Licence Number L7815/2001/11

Licence Holder Saracen Metals Pty Ltd

Premises North Eastern Goldfields Operations

Amendment

Figure 4b: Location of TSF groundwater monitoring bores, including new bores at MB7 and MB8.

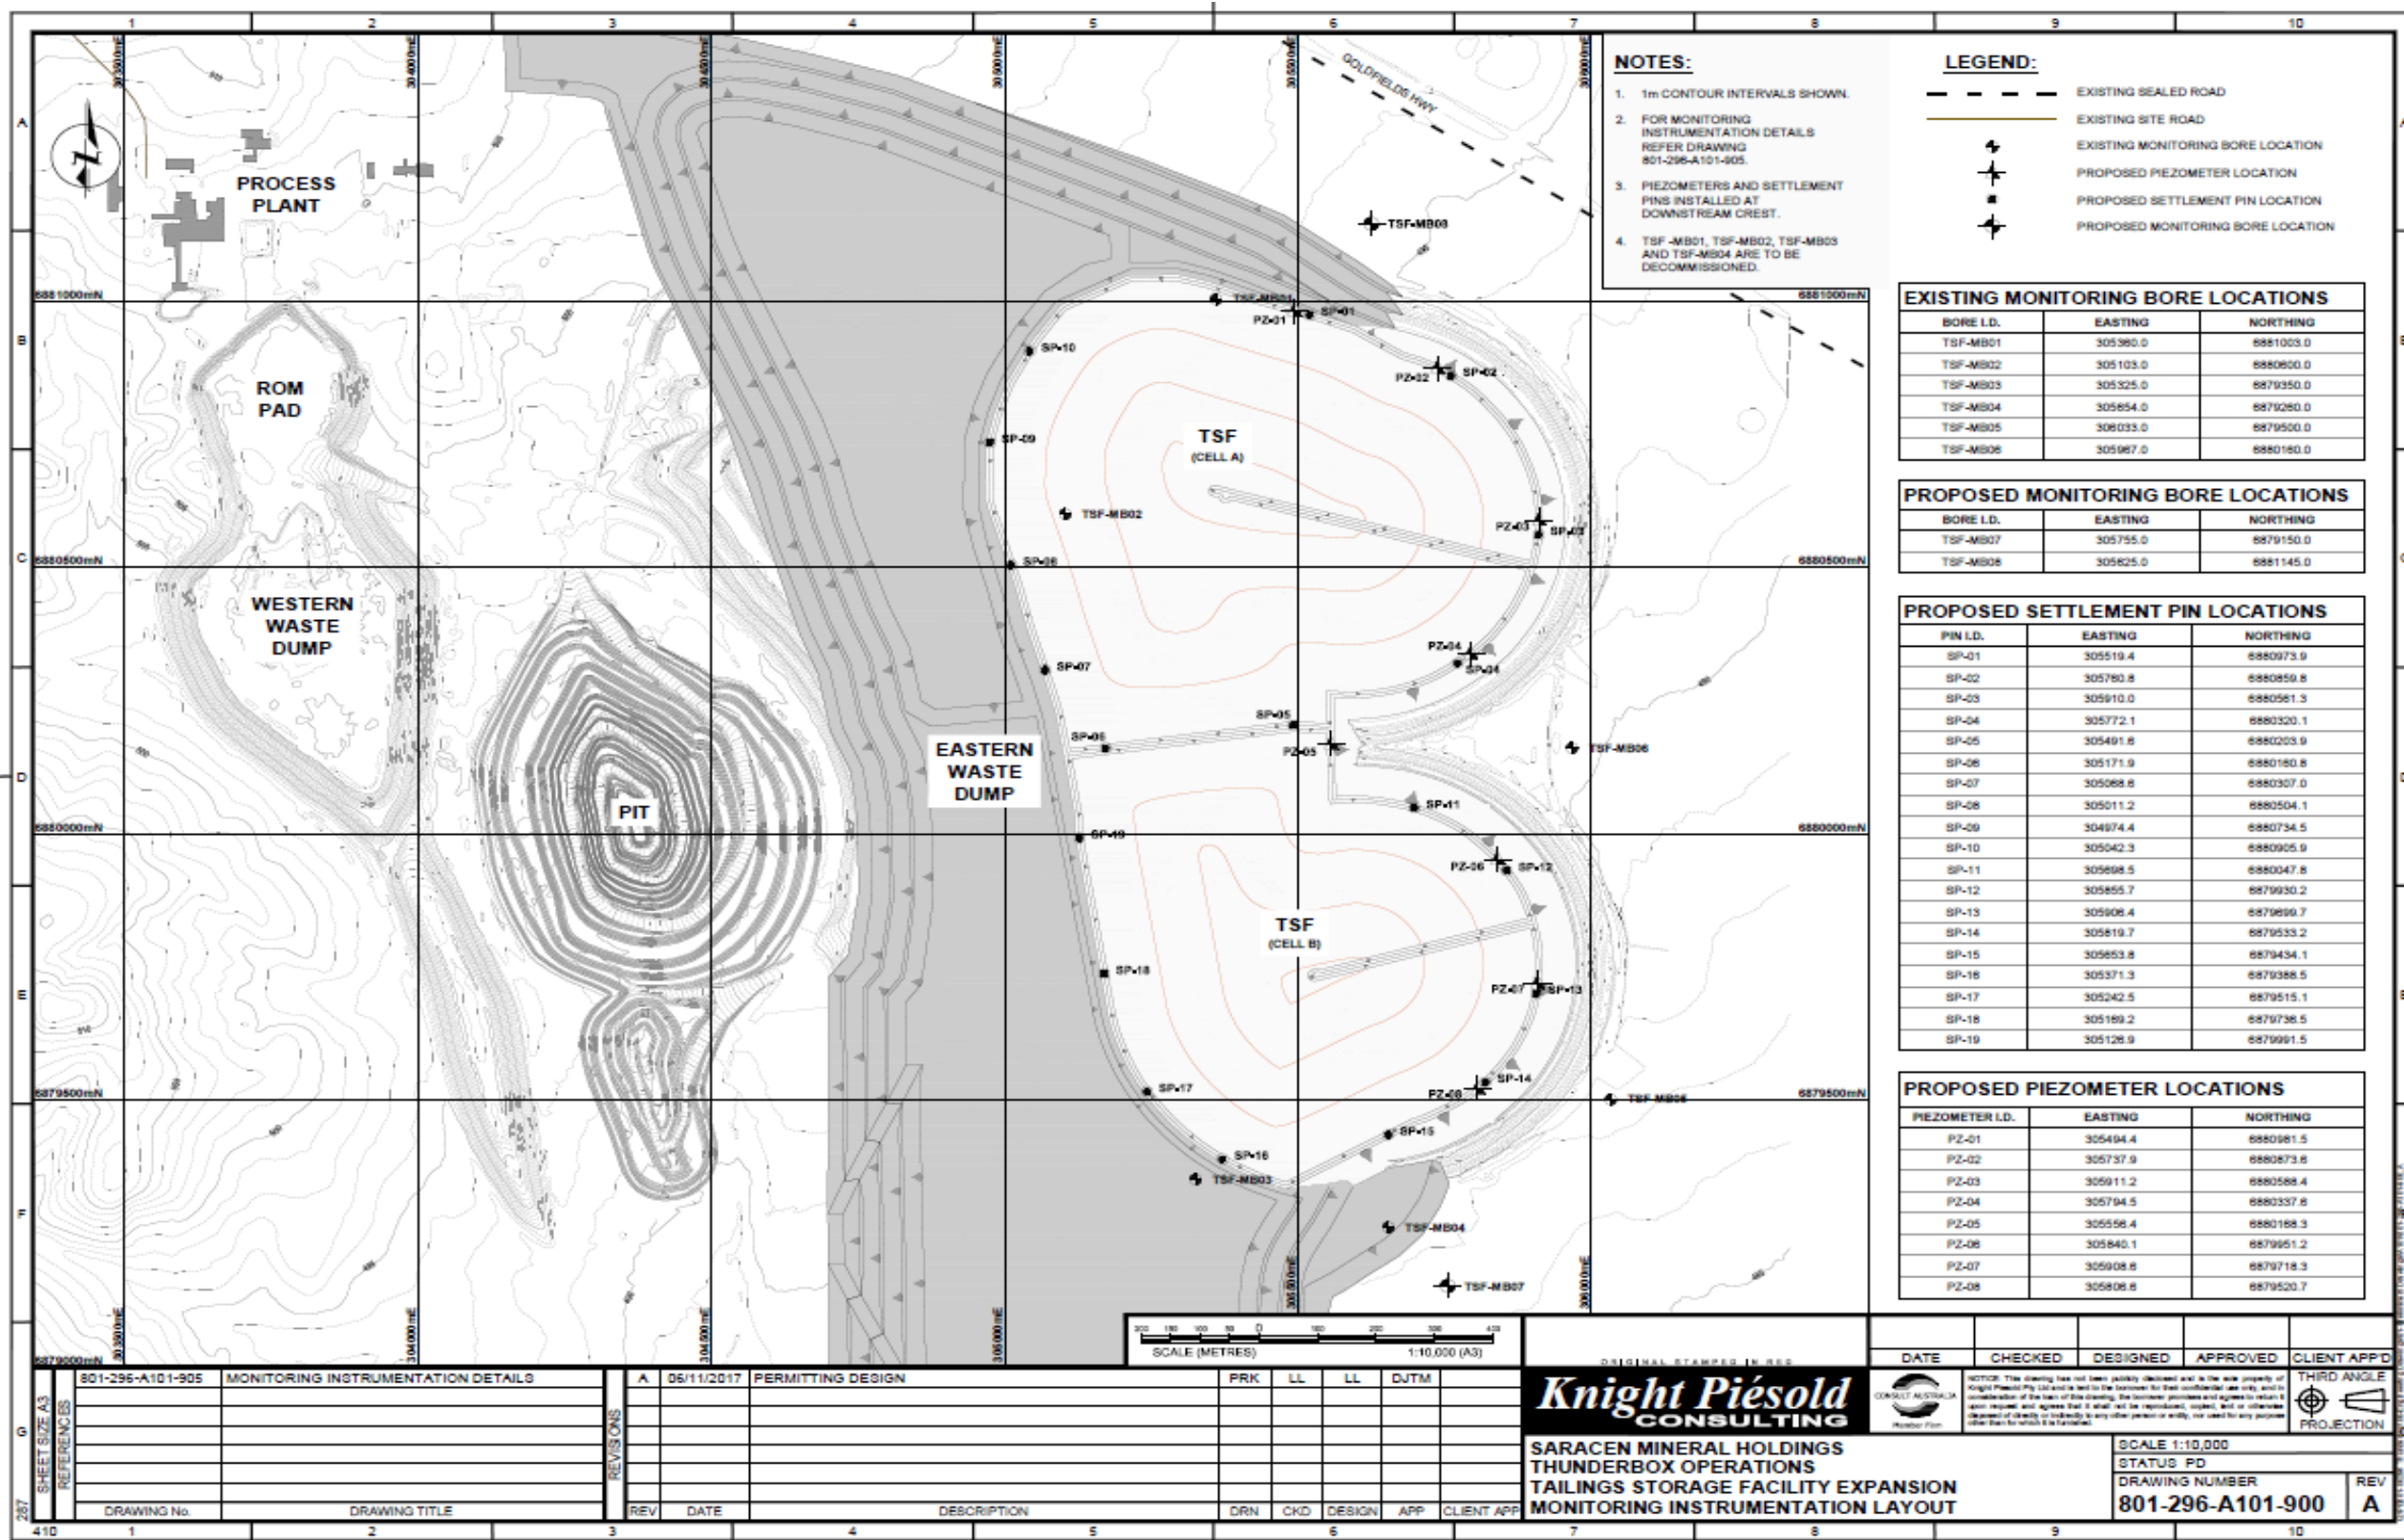
6. Schedule 1 of the Licence is amended by the addition of Figure 4b below:

Monitoring point reference and location	Parameter	Limit	Units	Averaging period	Frequency	
Monitoring bores MB2, MB4, MB5 and MB6 <u>MB7S, MB7D</u> <u>MB8S, MB8D</u> <u>(Location of new bores as shown in Figure 4b following.)²</u>	pH ¹	6.0 to 9.0	-	Spot sample	Quarterly	
	Standing water level (SWL)	>4	mbgl			
	Total dissolved solids (TDS)	<1500	mg/L			
	Weak acid dissociable cyanide (WAD CN)	<0.5				
	Arsenic (As)	<0.5		mg/L	Spot sample	Six monthly
	Antimony (Sb)	-				
	Bicarbonate (HCO ₃)	-				
	Calcium (Ca)	-				
	Carbonate (CO ₃)	-				
	Cadmium (Cd)	-				
	Chloride (Cl)	-				
	Chromium (Cr)	-				
	Cobalt (Co)	-				
	Copper (Cu)	-				
	Total cyanide (CN)	-				
	Iron (Fe)	-				
	Lead (Pb)	-				
	Magnesium (Mg)	-				
	Manganese (Mn)	-				
	Mercury (Hg)	-				
Molybdenum (Mo)	-					
Nickel (Ni)	-					
Nitrate (NO ₃)	-					
Potassium (K)	-					
Selenium (Se)	-					
Sodium (Na)	-					
Sulphate (SO ₄)	-					
Thallium (Tl)	-
